**TESORO
LOS ANGELES REFINERY
INTEGRATION AND COMPLIANCE PROJECT
FINAL
ENVIRONMENTAL IMPACT REPORT**

VOLUME VI: Appendix G (Comment G1-78.167 – G1-81 Attachment 23)

SOUTH COAST AIR QUALITY MANAGEMENT DISTRICT

ENVIRONMENTAL AUDIT, INC.

Figure 78.177-1

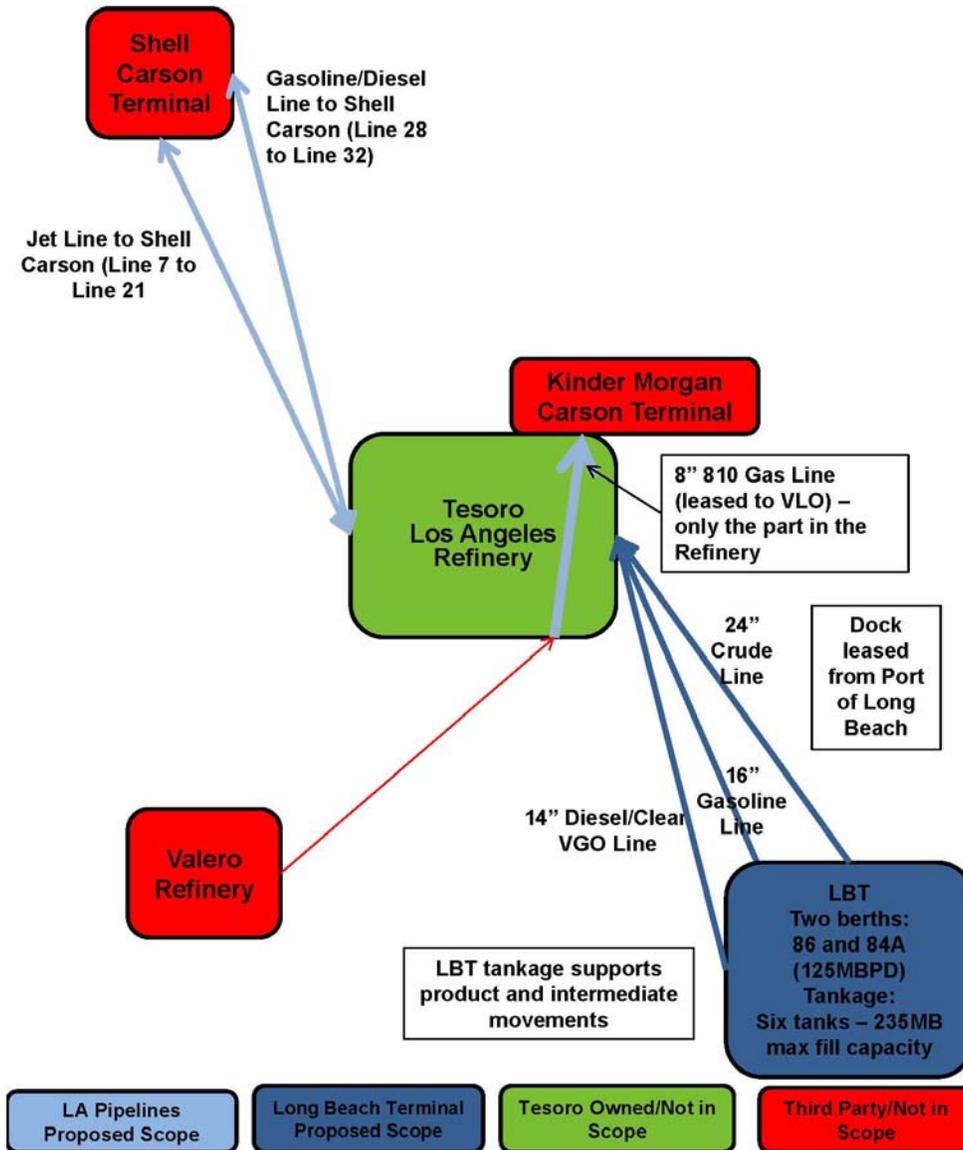
The information reviewed below, summarized in Figure 10, suggests that the Project is part of Tesoro Logistics’ plans to expand its terminals.²¹⁹

Figure 10 of Comment G1-78.177, while somewhat illegible (a more legible copy is shown in Figure 78.177-1), is a depiction of the assets associated with an asset transfer between Tesoro Refining & Marketing Company and Tesoro Logistics Operations. The transfer occurred in 2012 and involved previously existing Tesoro assets being reassigned between two Tesoro entities. The asset transfer is not related to the proposed project in any way because these operations commenced in 1967 and are ongoing. This was an unrelated activity that is part of the baseline.

Figure 11. Crude Oil Sources for CA²²⁴

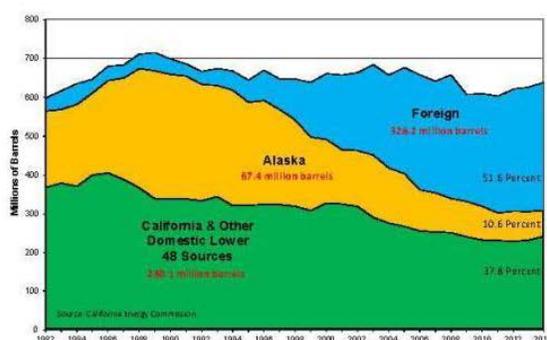
As shown in Figure 11, the decline in supply from California (and Alaska) crudes has been replaced by increases in marine imports from foreign sources.

The comment quotes Tesoro testimony for the Vancouver Energy Project as one source of evidence that the production of California crude oil is declining. California crude oil production has declined over the last ten years; however, it has also stabilized in recent years (see Response G1-78.186). As shown in comment Figure 11, both California and ANS production have stabilized in recent years (2010 to present). Although the decline may have been expected to continue, California and ANS crude oil production has not continued to decline. Therefore, there is no foreseeable need to replace California and ANS crude oils (ANS already is delivered by marine vessels) and there is no foreseeable increase in marine vessel deliveries from the potential replacement of pipeline deliveries.

Figure 12.
Event Tree for Vapor Cloud Explosions and Flash Fires³²⁰

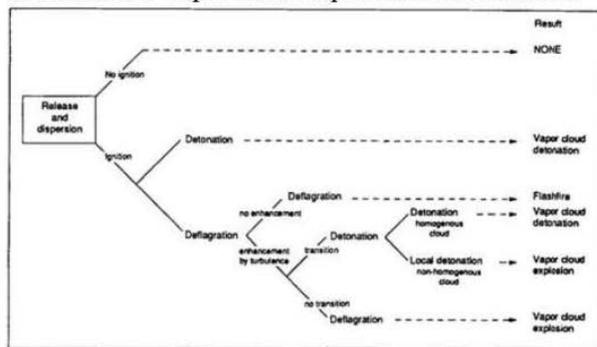
The types of accidents that could occur when a flammable material is released and an ignition source is encountered are summarized in the event tree in Figure 12. The EIR failed to consider most of these possible scenarios. Rather, the DEIR asserts without any supporting analysis that there are certain “worst-case scenarios” for the modified process units.³¹⁹ The DEIR fails to document the process used to select these scenarios, preventing meaningful public review. Thus, the DEIR fails as an informational document.
